Planning Commission Meeting Agenda
Hartland Township Hall
Thursday, May 27, 2021
7:00 PM

Subject: Site Plan Application #21-008
(Amendment to Conceptual Master Plan for Shops at Waldenwoods PD)

Subject: Site Plan Application #21-004 (Amendment to Hartland Marketplace Planned Development)

EXHIBIT B-1
PROPOSED CONCEPTUAL
MASTER PLAN

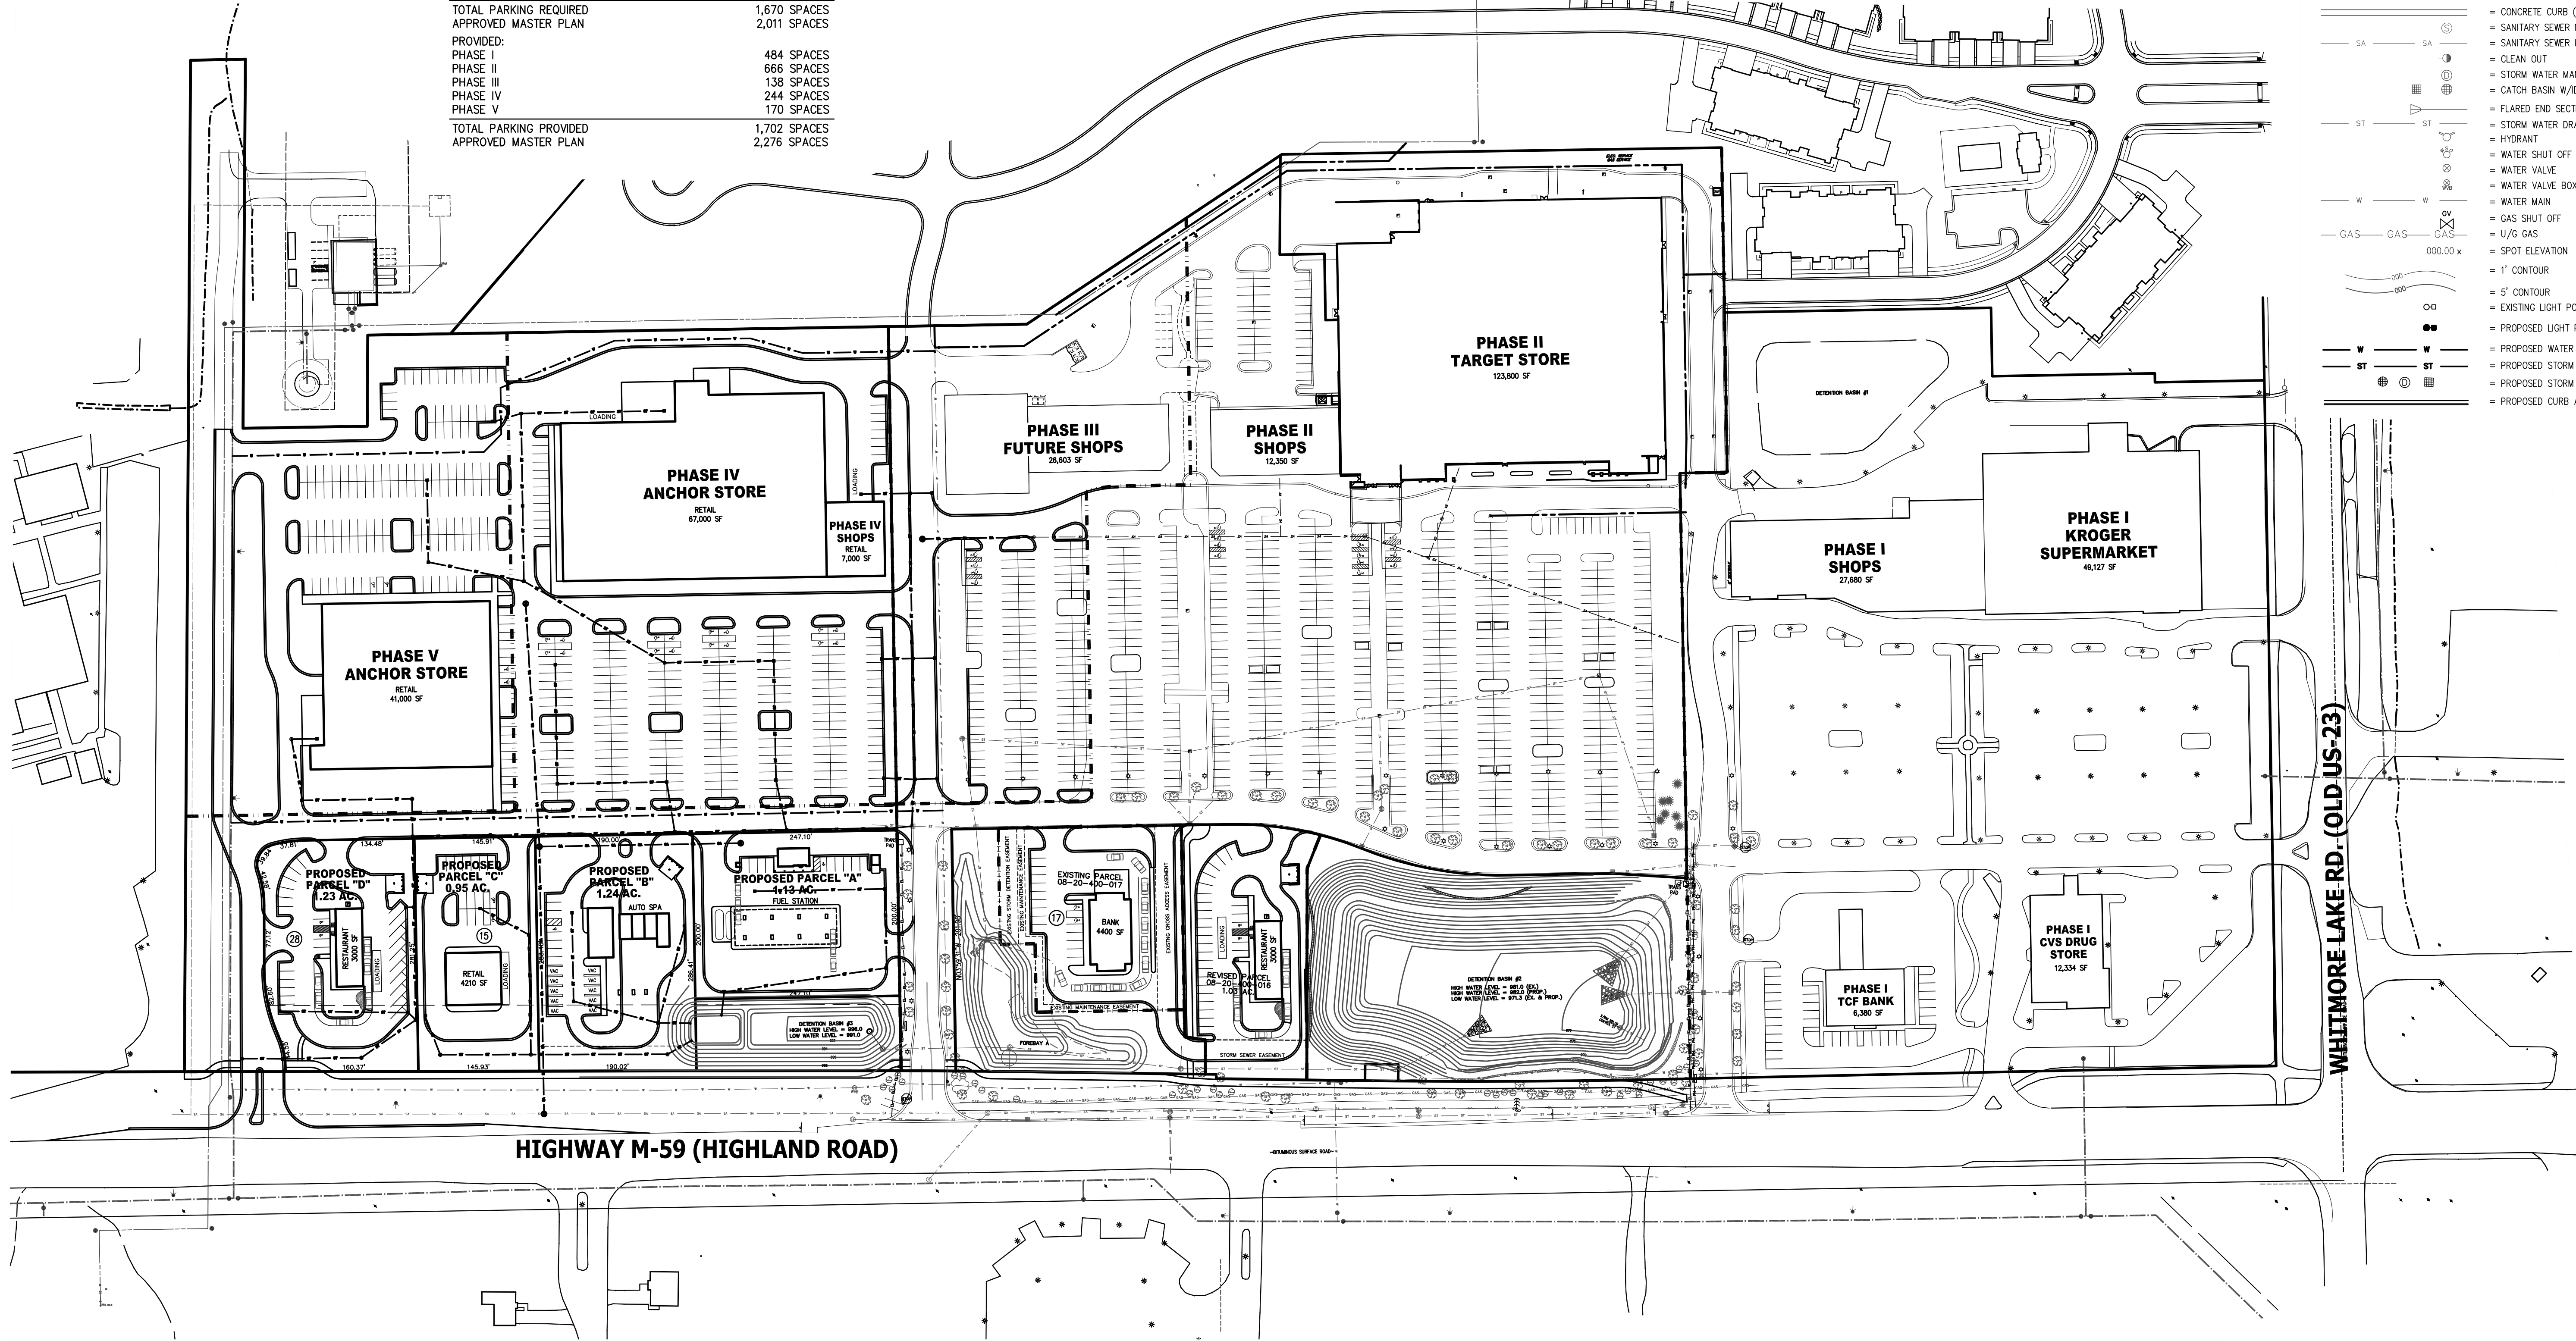
The proposed Conceptual Master Plan is primarily focused on the southerly 350 feet of the development, between the existing Target entry drive on Highland Road and the west property line of the development. The previously approved Conceptual Master Plan in this same area depicted three (3) individual commercial buildings (ranging from 5,000 to 8,00 square feet in size), an anchor store (45,520 square feet in size), three (3) detention basins, and substantial parking areas, along the frontage of Highland Road.

The following revisions are depicted on the proposed Conceptual Master Plan:

- Creation of four (4) individual parcels for future commercial development along Highland Road, in the southwest corner of the development
- Reduction of Phase 4 and Phase 5 retail anchor store footprints to reflect the addition of the four (4) new parcels
- Modifications to parking and internal vehicular circulation
- Modifications to the storm water management system and detention basins
- Other site modifications to address future Highland Road expansion plans
